**CCO #GC-001**

Project: AS7.001.001 - Ogdensburg CSD Capital Improvement Project
1100 State Street
Ogdensburg, New York 13669

Change Order Authorization #GC-001: CE #003 - Golden Dome Roof Sealant Credit

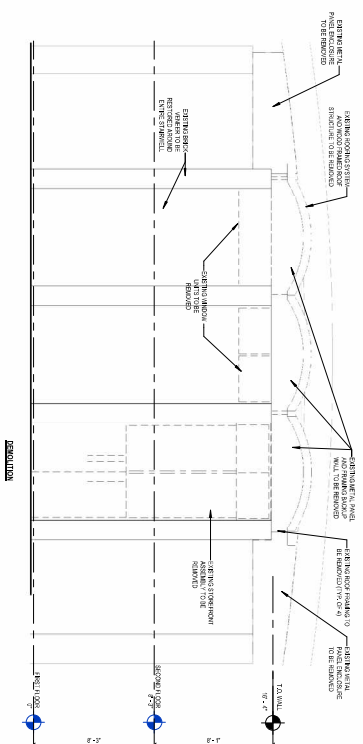
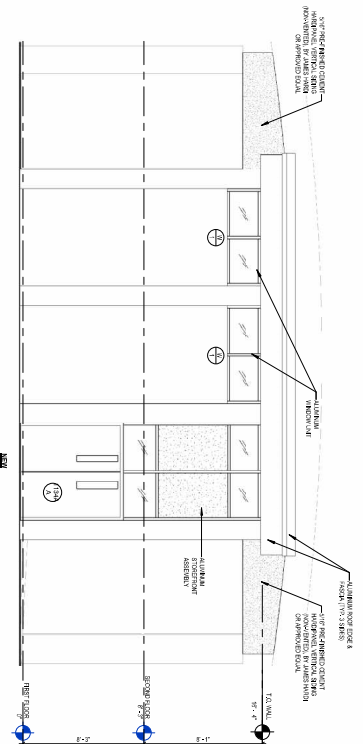
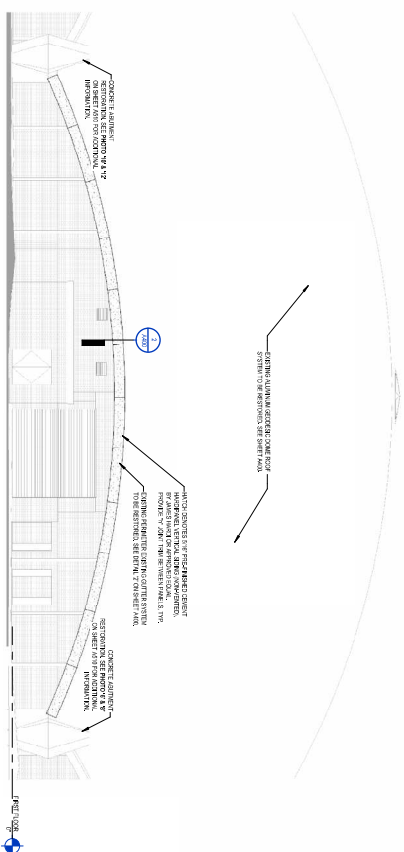
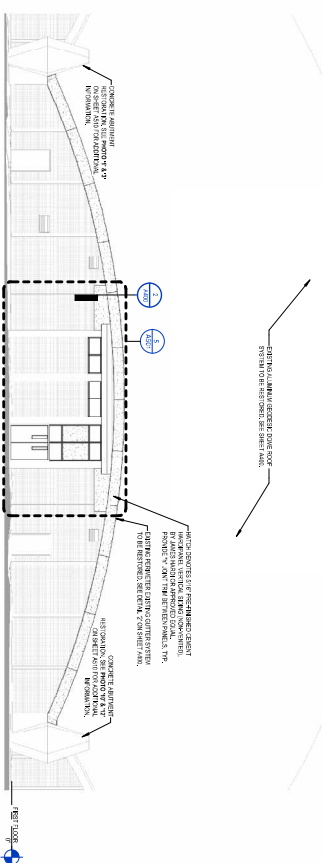
A.	Owner Requested
B.	Under the Capital Project, the Golden Dome was scheduled to receive a clear fluid-applied waterproofing system over all metal roofing system joints & connections at the Golden Dome as detailed on Contract Drawings (1B) A400, A500 & A501; and as described in Specification Section 07 5600 Fluid-Applied Roofing.

C.	During construction, the Owner requested that the exterior waterproof coating on the roofing system not be installed due to the redundancy of protection against stormwater infiltration from other measures being taken; and for preservation of funding to address other needs within the capital project. The General Contractor was still required to replace any deteriorated sealant at the metal roofing system joints & connections; as well as provide an intumescent spray foam insulation system on the interior.

D.	Deduct for all labor, materials & equipment to eliminate the restoration requirements for base bid, clear fluid-applied (BCI Domeseal or equal) waterproofing system over all metal roofing system joints & connections at the Golden Dome.
